Access Compliance Report

Public Rights-of-Way

(Curb Ramps)

Intersection ID: 6357	Main Street: CENTURY_OAKS_LN	Cross Street: WATERSTONE_LN	Location: S
ADA ID: 26CBF89086F2	Ramp Type: Perp	Initial Pass/Fail: Fail	Overall Compliance: No
		Severity Score: 35

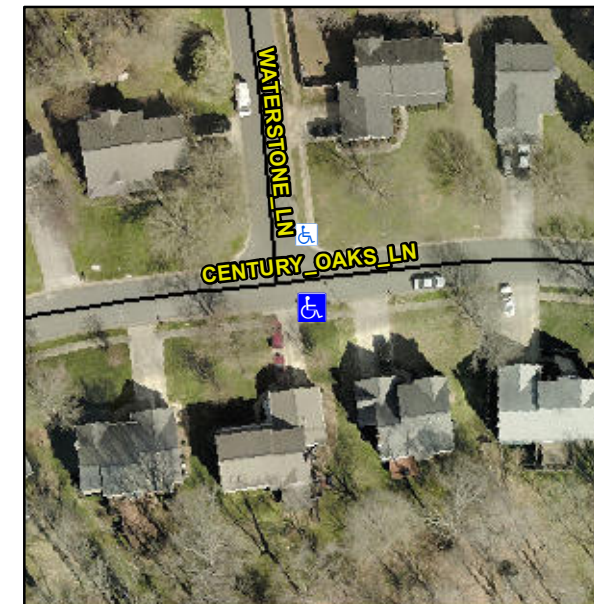
Not Found, R304.5.1, R304.2.2, R304.5.3

Compliance	Description	Data	Compliance	Description	Data
N/A	Ramp Length (in)	47.0	No	Ramp Slope (%)	12.9
No	Ramp Width (in)	39.0	No	Ramp XSlope (%)	4.9
N/A	Flare Type LT	N/A	N/A	Flare Type RT	N/A
N/A	Flare Slope LT (%)	N/A	N/A	Flare Slope RT (%)	N/A
N/A	Flare Traversable LT?	N/A	N/A	Flare Traversable RT?	N/A
N/A	Landing Length (in)	N/A	N/A	DWS Provided?	N/A
N/A	Landing Width (in)	N/A	N/A	DWS Contrast?	N/A
N/A	Landing Slope (%)	N/A	N/A	DWS Length (in)	N/A
N/A	Landing X Slope (%)	N/A	N/A	DWS Full Width?	N/A
N/A	Landing Curb? (Y/N)	N/A	N/A	DWS Offset (in)	N/A
N/A	Shared Landing?	N/A			
N/A	Gutter Ponding?	N/A	N/A	Gutter Slope (%)	N/A
N/A	Gutter Lip Ht (in)	0.75	N/A	Gutter X Slope (%)	N/A
N/A	Painted X Walk1?	No	N/A	Painted X Walk2?	N/A
	X Walk 1 Direction	To N		X Walk 2 Direction	N/A
N/A	X Walk 1 Width (in)	N/A	N/A	X Walk 2 Width (in)	N/A
	X Walk 1 Slope (%)	6.7		X Walk 2 Slope (%)	N/A
	X Walk 1 X Slope (%)	3.6		X Walk 2 X Slope (%)	N/A

Remove & Replace Entire Ramp.
